LiDAR Quality Assessment Report

UT_GSLTooeele_2011

This data set created using LiDAR points collected from airborne surveys completed on October 18, 2012 and covers approximately 106 square miles contained in the following county(s): Tooele County, Utah; Salt Lake County, Utah.

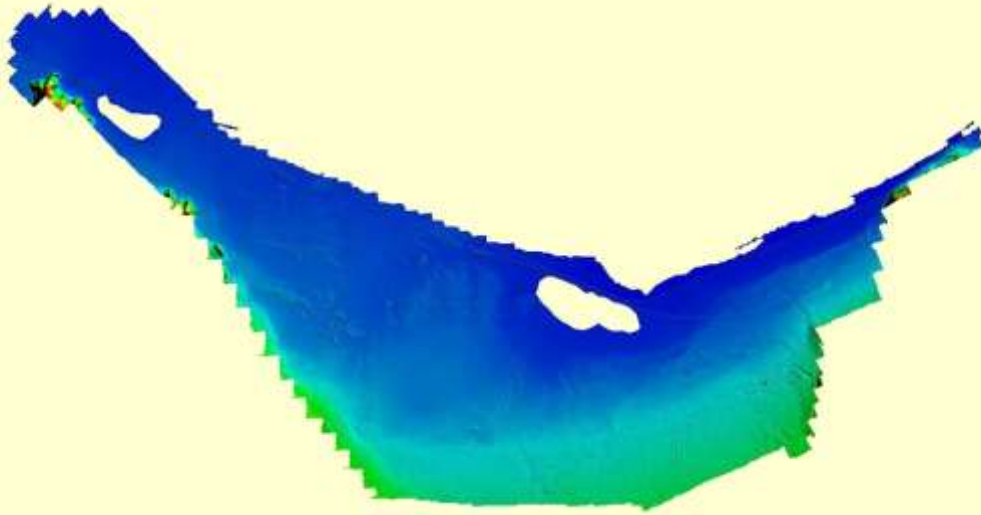
DEM Tiles do not perfectly Conform to the Tiling Scheme in terms of quantity, i.e., 95 DEM Tiles out of a Tile Scheme of 98 Tiles. However these missing tiles are outside the project extent and do not affect the final mosaicked DEM. Missing Tiles are: 25, 39, and 44.

Mosaic of original DEM tiles above, many water areas gridded as "no data".

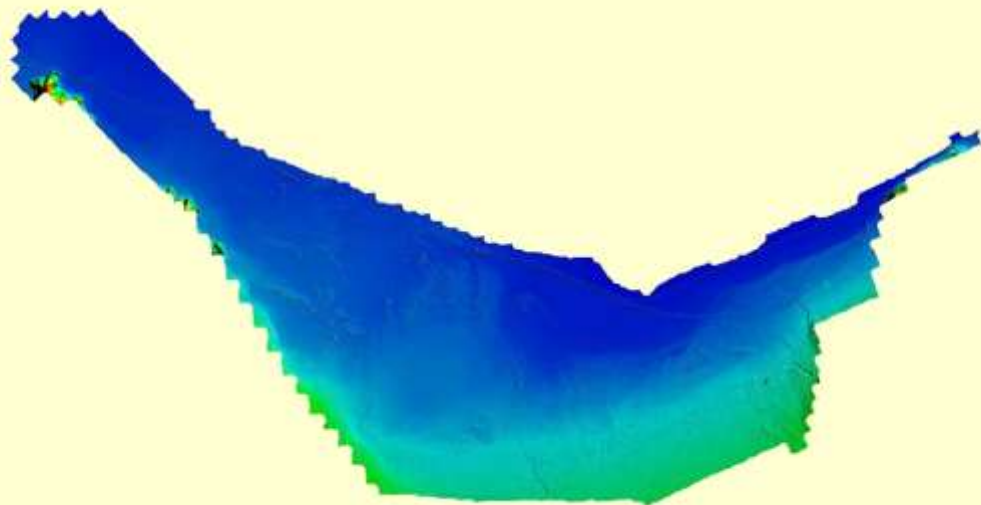
In order to make the DEM usable in the 1/9th NED the Water needed to have a value, A final mosaic was created by the USGS that coded each interior lake with a constant (flat) value of the lowest bordering pixel. The project boundary for the project was also determined to be the maximum swath extents and was buffered in by 100 Meters and cut out on the southern portion to ensure there were no gaps in the data due to the flight lines. The final product sent to the NED should be free of data voids and have adequate point density for gridded areas included in the final mosaicked DEM. This also has an accompanying DEM Project Footprint and is 96.05 SqMi.

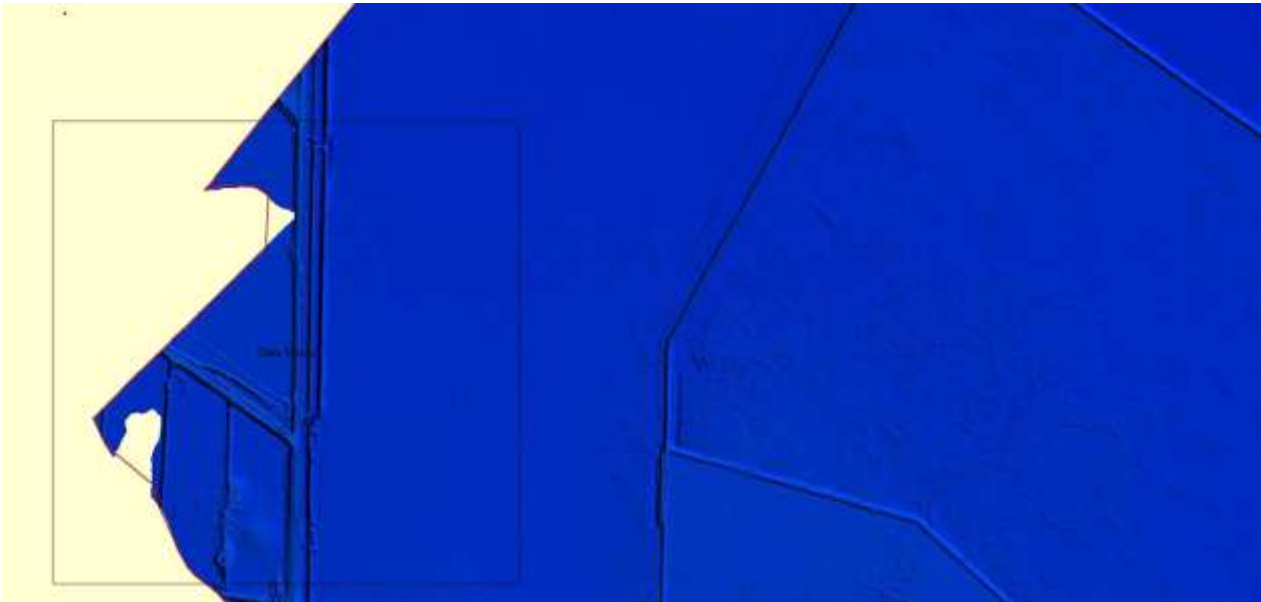
The Project extent and gridded data did not match, in order to reduce edge artifacts and data voids the final DEM was buffered in by 100 Meters.

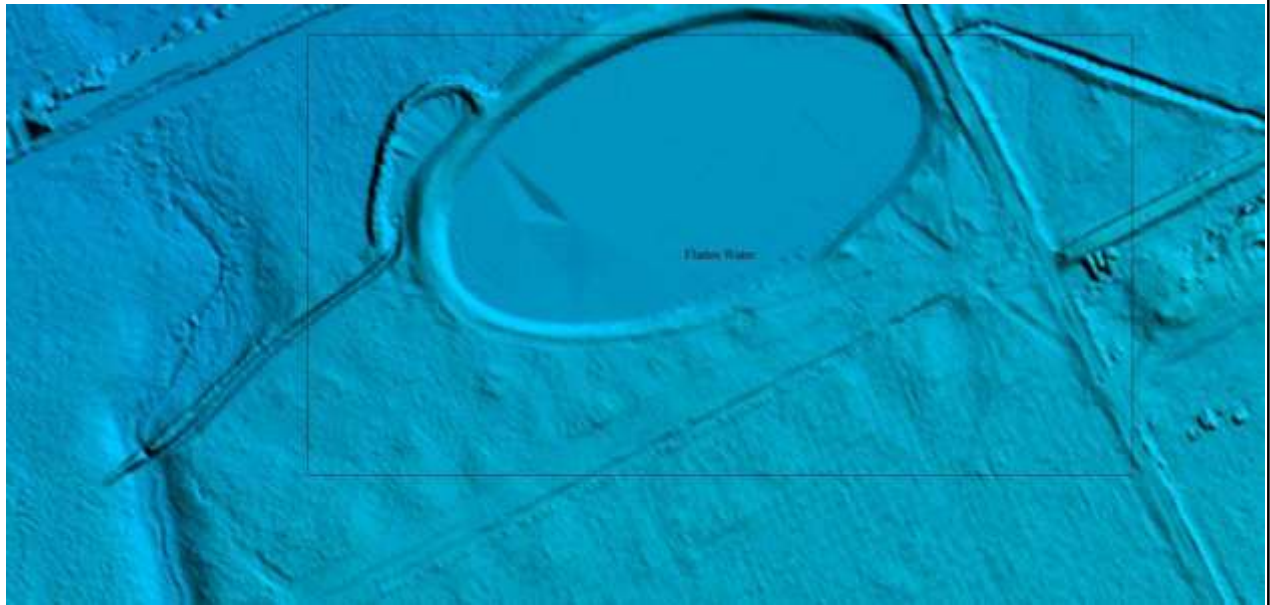
A few instances of distinct waterbodies larger than 2 Acres could be flattened.

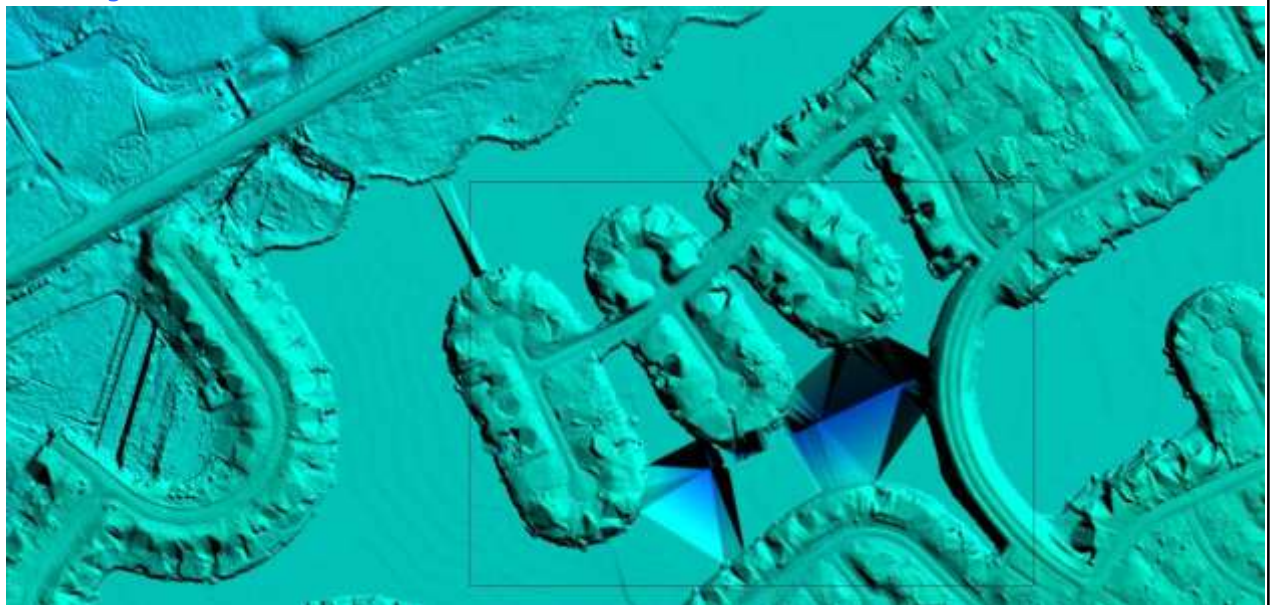
There was a single instance of a large pit/sink in the water area pictured above.
